# NEBRASKA CAPITOL ENVIRONS COMMISSION

## AGENDA

July 28, 2023

## NEBRASKA CAPITOL ENVIRONS COMMISSION STAFF REPORT

## ATTACHMENT B – Renderings

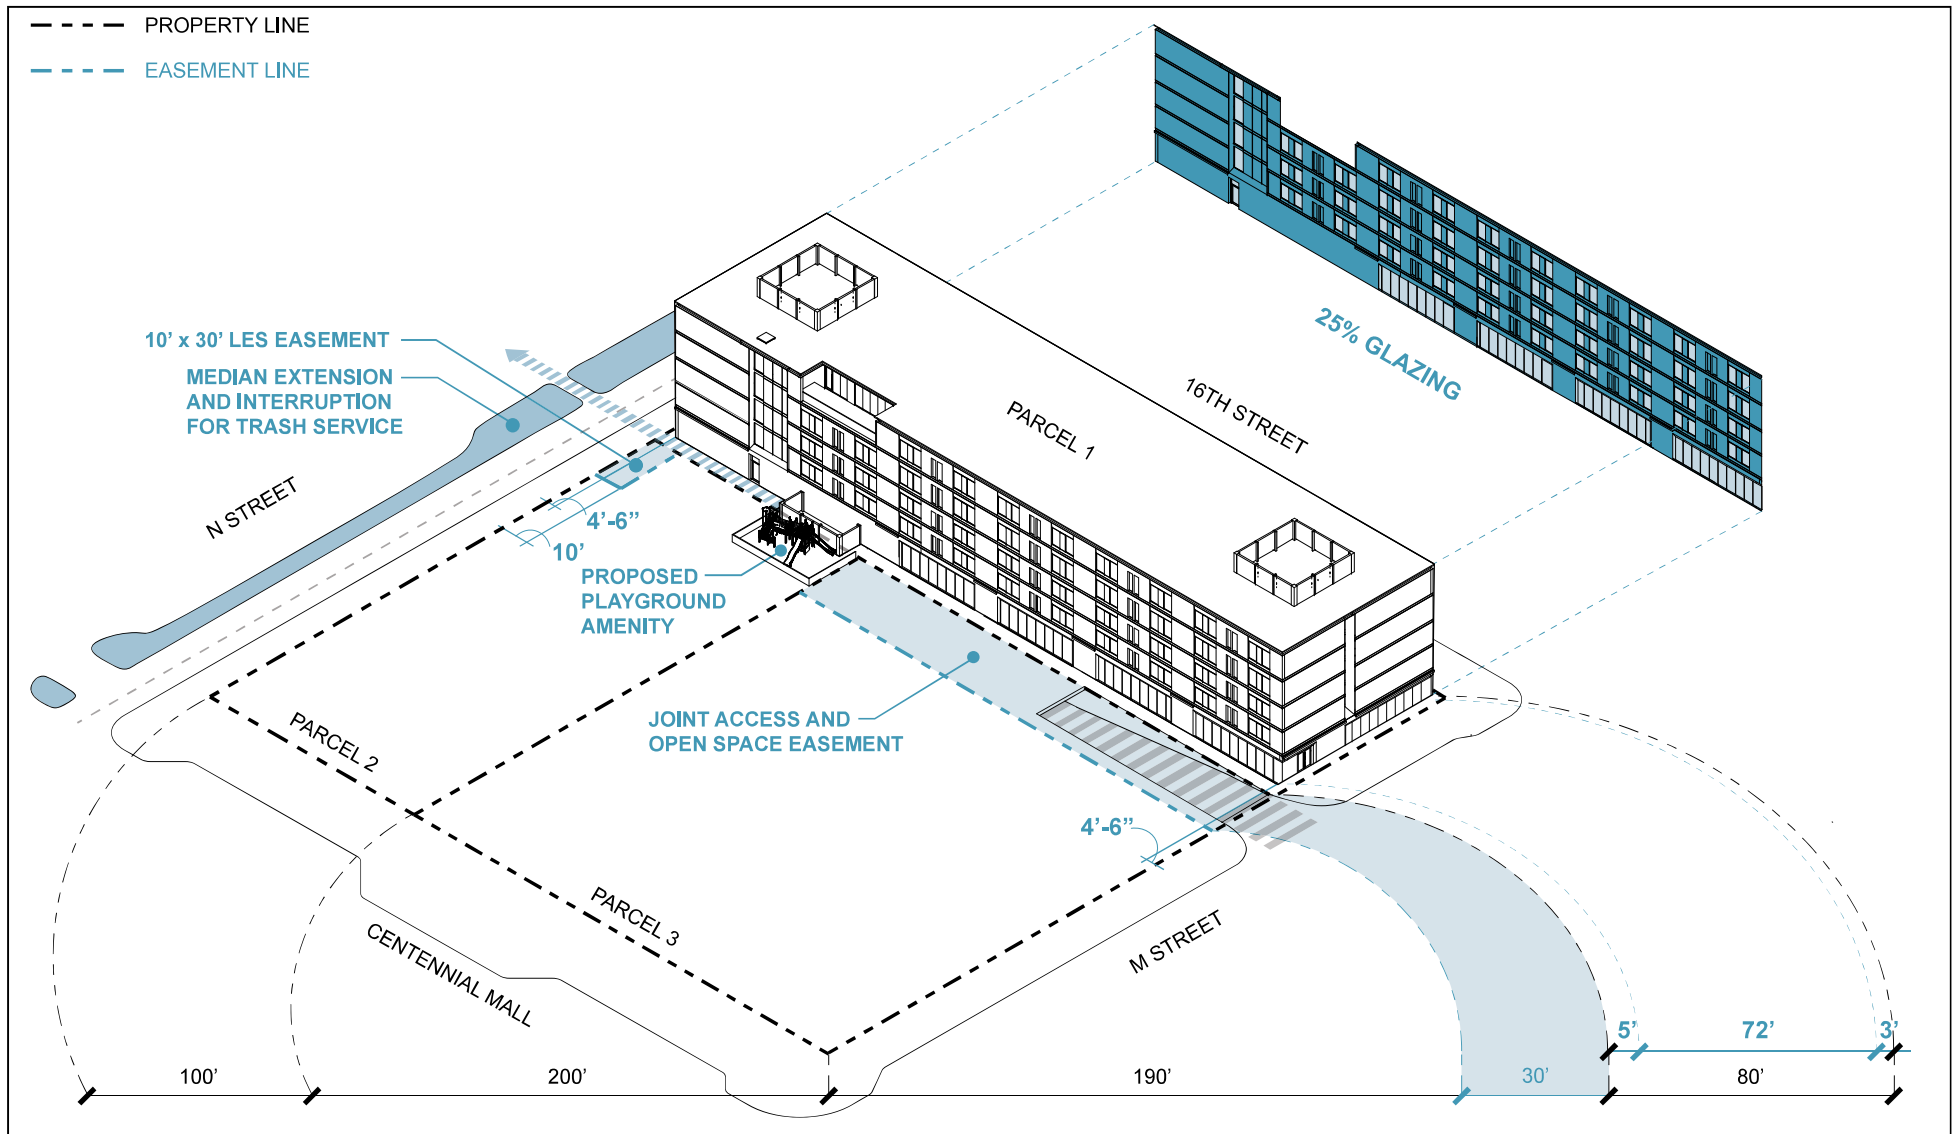
- **Façade modifications** – The most noticeable façade change relates to the color palette for the façade. The original plans submitted in 2022 showed a light brick product on the lower level with a darker brick on the upper levels. The updated plans offer a reverse approach – light brick below and dark brick above. Beyond that, the widow placement/transparency appears to have been modified in subtle ways that do not appear to have a material effect on the quality of the facades.

*The images on the left represent the design approved in February 2022 and the images on the right show the modified design submitted for an updated certificate.*

In comparing the plans approved in February 2022 with those submitted as part of this review, staff believes that the façade-related changes do not result in a diminished project. The changes in the masonry choices are a matter of preference and not of quality or durability. Likewise, the modifications to the

### M AND N STREET SETBACK CONDITIONS

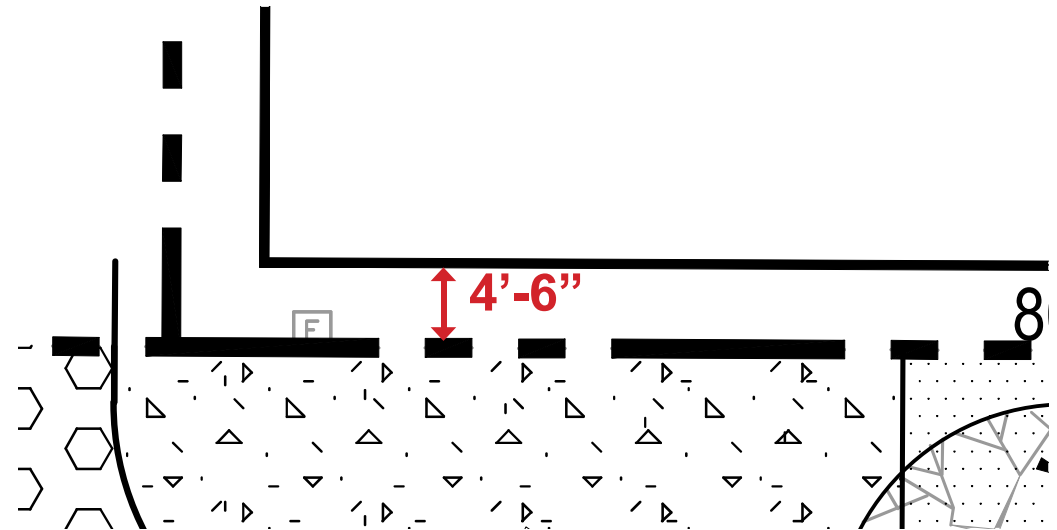
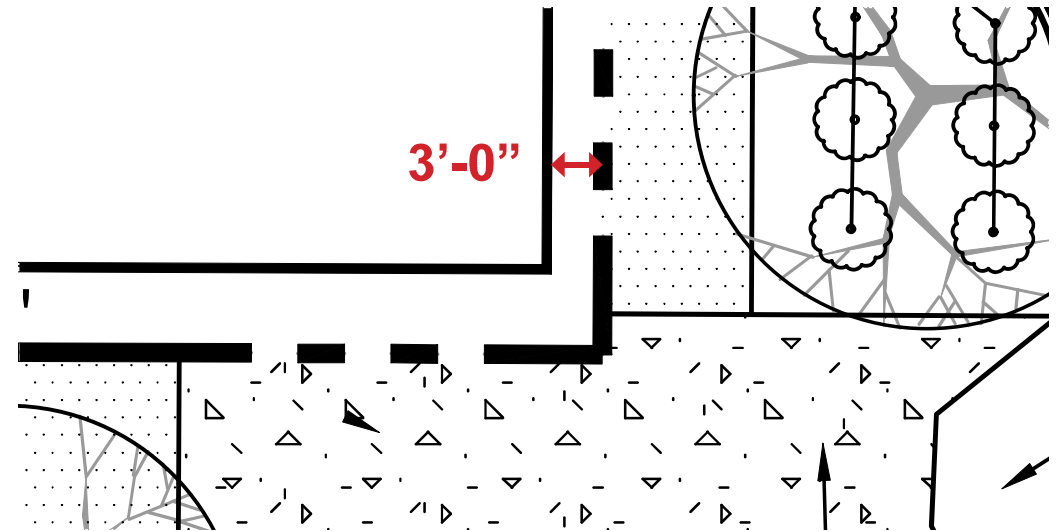
- **Building setback modifications** – The 2022 plans were processed and reviewed by staff with the assumption that the building was being built to the M, N and 16<sup>th</sup> Street property lines, as is standard for new development in downtown Lincoln. This was not a topic of discussion at that February 2022 meeting, per the approved minutes. The modified proposal shows a 3’ setback from S 16<sup>th</sup> Street, and a 4.5’ setback on the M and N Street sides.

In discussions with the applicant regarding the building setbacks, staff has conveyed a desire to have the project be built to the property lines, per the Downtown Design Standards. However, the applicant has made a case for why the small setbacks are necessary. Per the application material submitted, those reasons are as follows:

1. Affordable housing unit layout design is driving building footprint size. There is not sufficient additional space in the north/south parcel lot dimension for an additional housing unit to be integrated in the plan layout.
2. Design space is needed at the north along N street to locate intake air for underground parking ventilation, and also at the south along M street for exhaust air. This chase and its supporting structure must be included on the project property extents.
3. Indicated offsets from the front property lines allow that building footings will be able to be designed and constructed within project property boundaries, and will avoid any potential conflicts with City of Lincoln public easements for utilities.

Staff's perspective regarding the setbacks is a little more nuanced. The Downtown Design Standards are clear in their expectations and allowing a deviation of this nature impacts not only future urban design decisions on this block but also on the blocks that surround it. At the same time, one might argue that a setback of 3' or 4'-6" is not a distance that most will notice, and that the value add of the affordable housing and other uses to be contained within this block are much more important and relevant to the future of downtown and the Capitol Environs District. Ultimately, staff understands the complex nature of a project like this and seeks NCEC's guidance on how to proceed.

# ATTACHMENT B – Landscape Plan

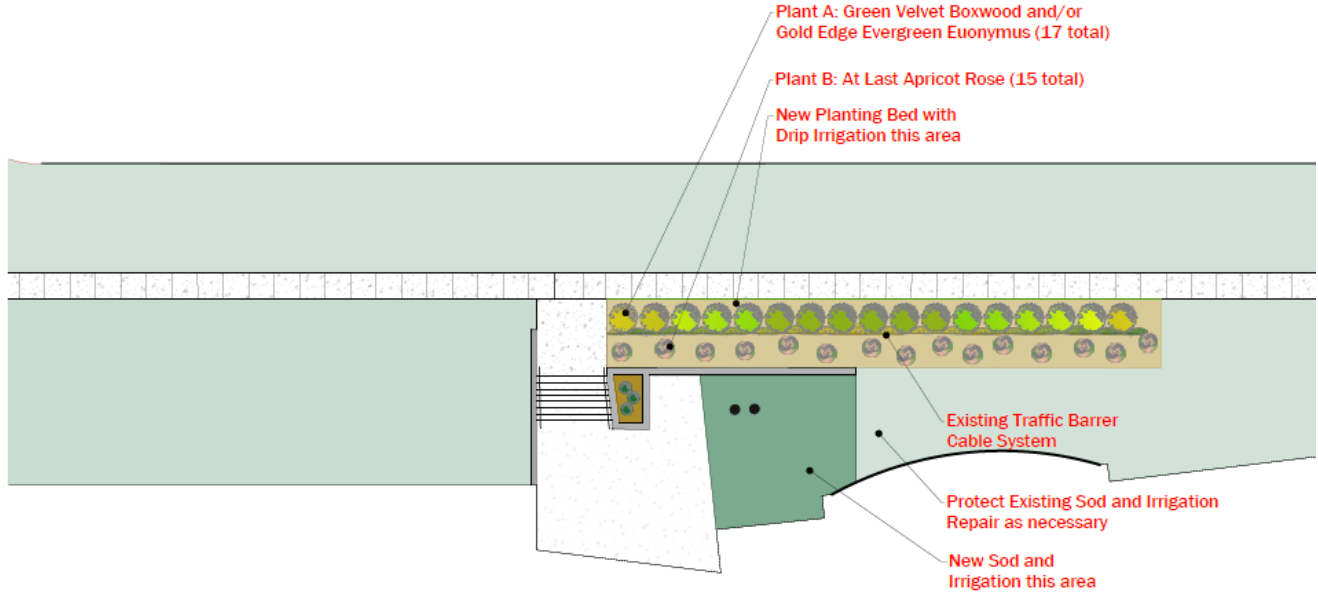
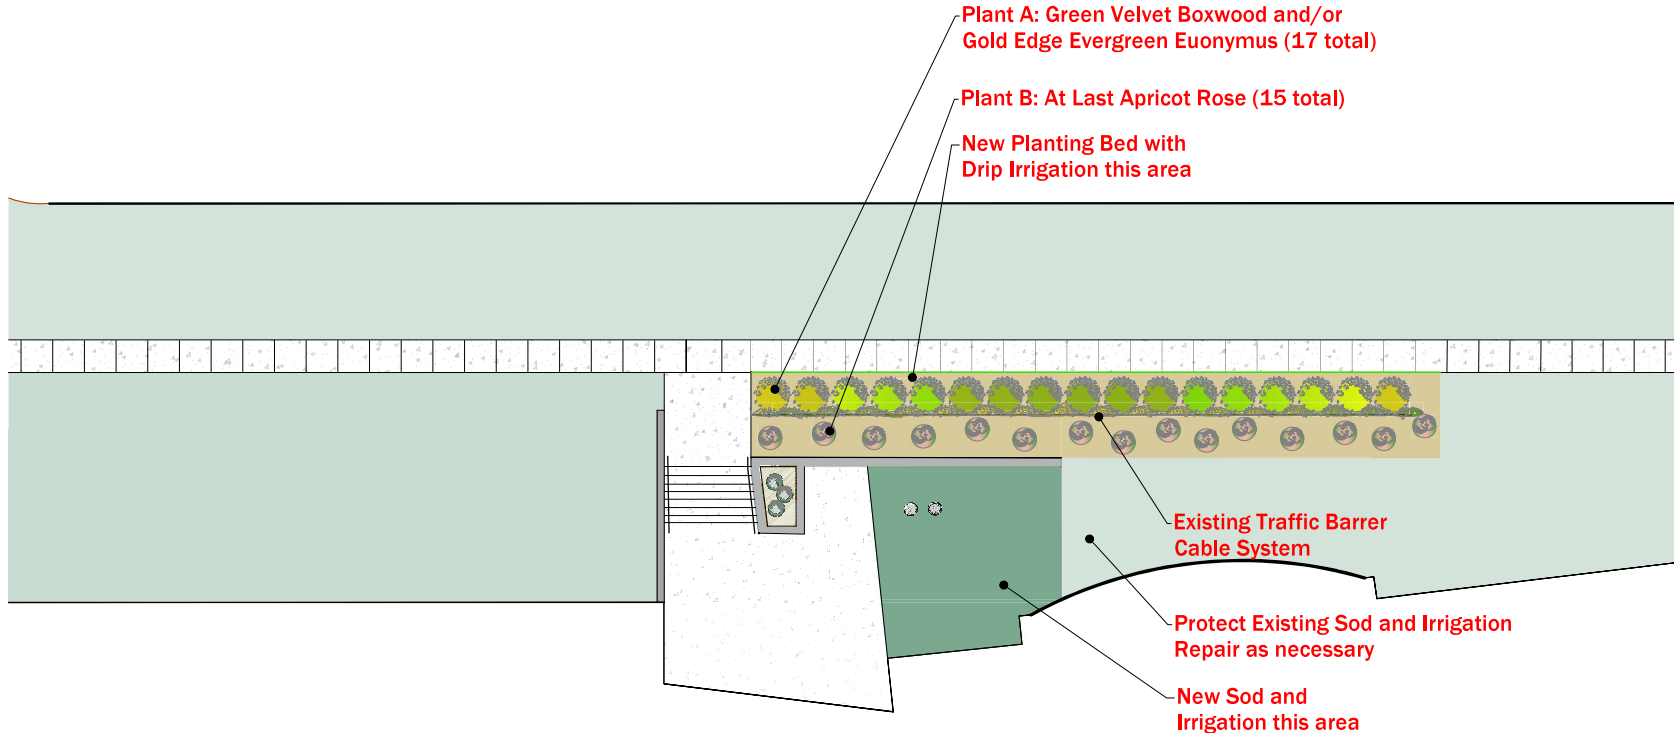
In December of 2022, the applicant submitted a revised design for the barrier system. The new plans eliminated the spherical barriers and replaced them with a cable restraint system that they planned to landscape to offset any negative visual impacts. Again, they were granted a Certificate of Appropriateness under the condition that they provide the Commission a landscape plan for review prior to planting.

They have now submitted such a plan and are looking for approval from the Commission to proceed with installation of that plan.

While the proposed landscape plan appears to meet the intent of the design standards, the Commission should weigh in on any specific concerns related to plant species, spacing, or maintenance of the proposed landscape improvements.

**Recommended finding:** The proposed landscape plan complies with the Capitol Environs Design Standards.

**Recommended action:** Approval of an updated Certificate of Appropriateness for the proposed work at 1821/1843 K Street.

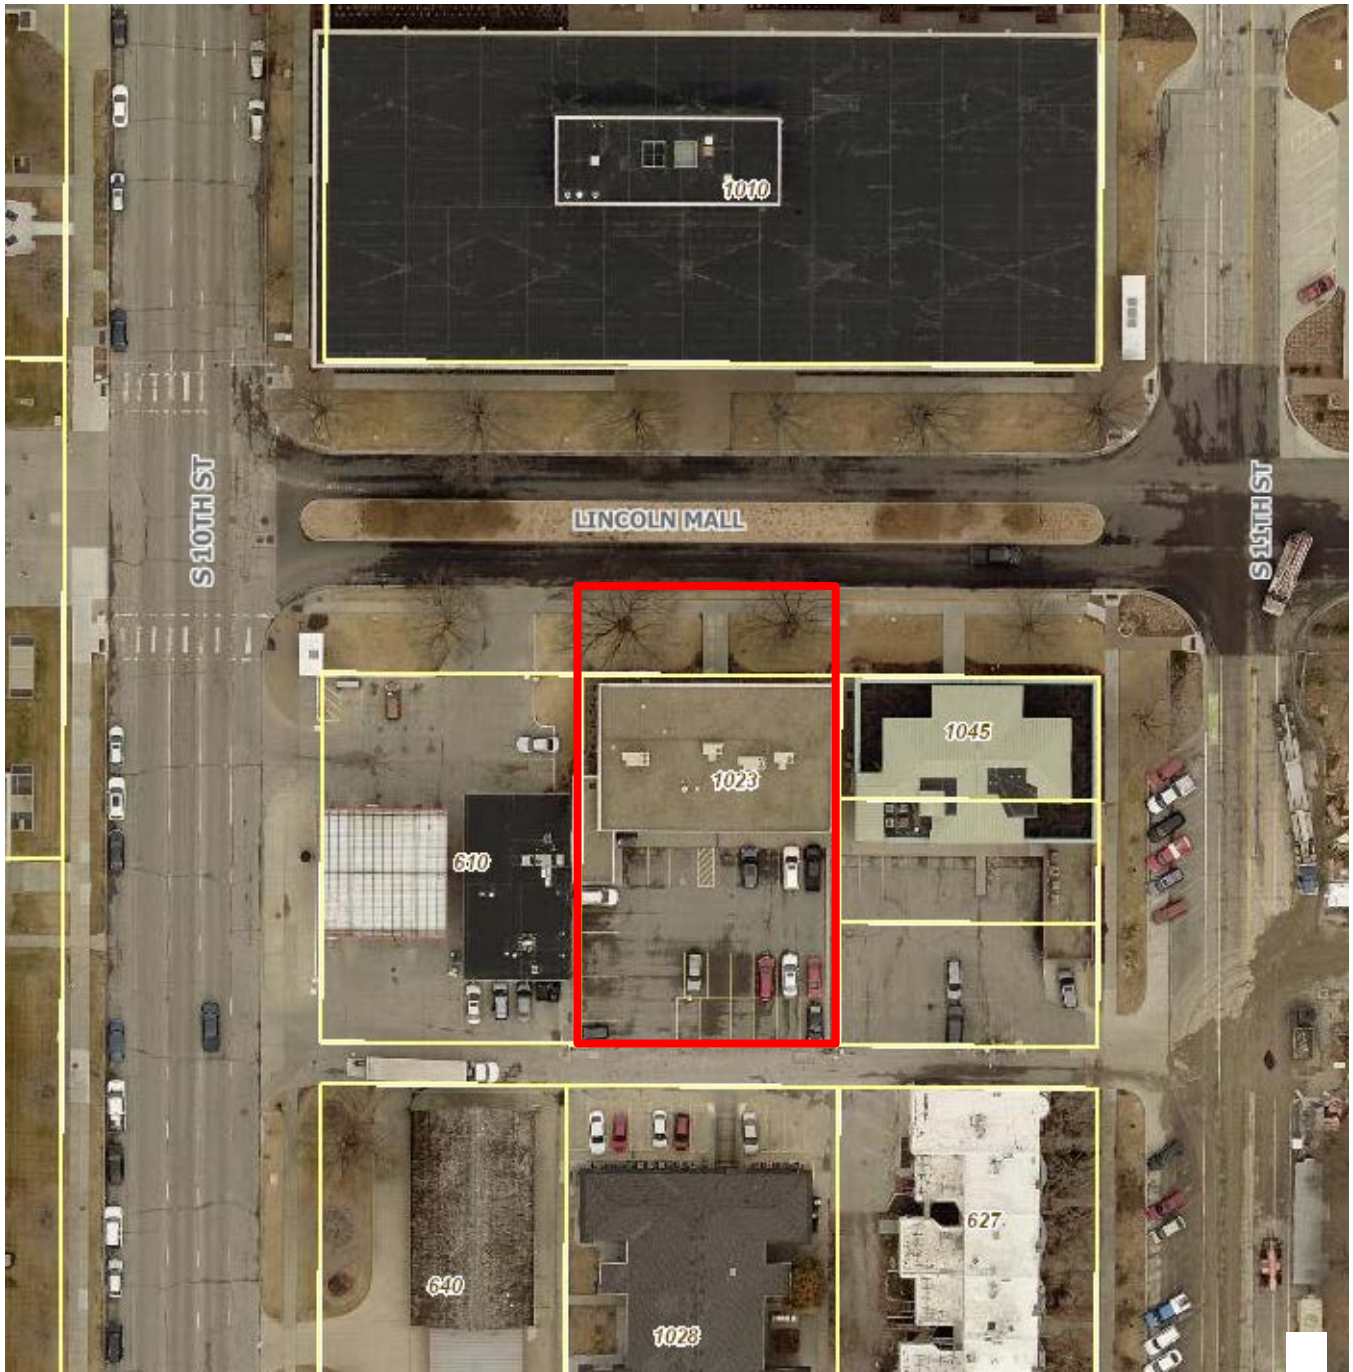
While the two racks proposed would be in front of the new Lincoln Literacy building at 1023 Lincoln Mall, they would be in the public right-of-way and accessible to anyone to use, not just Lincoln Literacy visitors. Though the Committee looked at locations behind the building, ultimately there wasn’t enough space to locate them adjacent to the parking and still provide pedestrian access along the sidewalk. Removing one of the limited number of parking spaces behind the building was also considered, but was ultimately determined to not be a preferable option. Finally, per the direction of the Commission, using a parking stall on 11<sup>th</sup> Street was explored, but it was determined that the location would not be easy to find for visitors along Lincoln Mall and that there are already existing racks nearby on H Street. Removing a parking stall on 11<sup>th</sup> is also challenging due to the parking demand along the corridor.

This proposal, while relatively minor in its immediate impact on Lincoln Mall, is a difficult one to weigh because of the impact it could have on future decisions. The design standards do not directly speak to the use of bike racks on the malls, nor do they speak to the use of some other common site furnishings and amenities like trash receptacles or bus stop shelters. Yet, each of those elements (including bike racks) exist on Lincoln Mall today. In 2021, NCEC approved the addition of bike lanes to Lincoln Mall, though no additional racks were added to the public right-of-way at that time. Looking beyond Lincoln Mall, Centennial Mall also has many examples of bike racks being integrated into the streetscape.

On the other hand, there is a clear precedent that has been set with the NEBCO redevelopment projects along Lincoln Mall and the related public streetscape improvements to locate the bulk of the bike parking behind the buildings fronting the mall, where the vehicular parking exists. Though there is nothing that binds this decision to previous improvements, they can certainly be viewed as a guide for consideration.

Staff is not offering a recommended finding or action here because the design standards do not provide adequate guidance to make such recommendations. Instead, staff is asking the Commission to consider the request and offer both a decision on this particular proposal as well as guidance for addressing future proposals within the broader context summarized in this staff report.
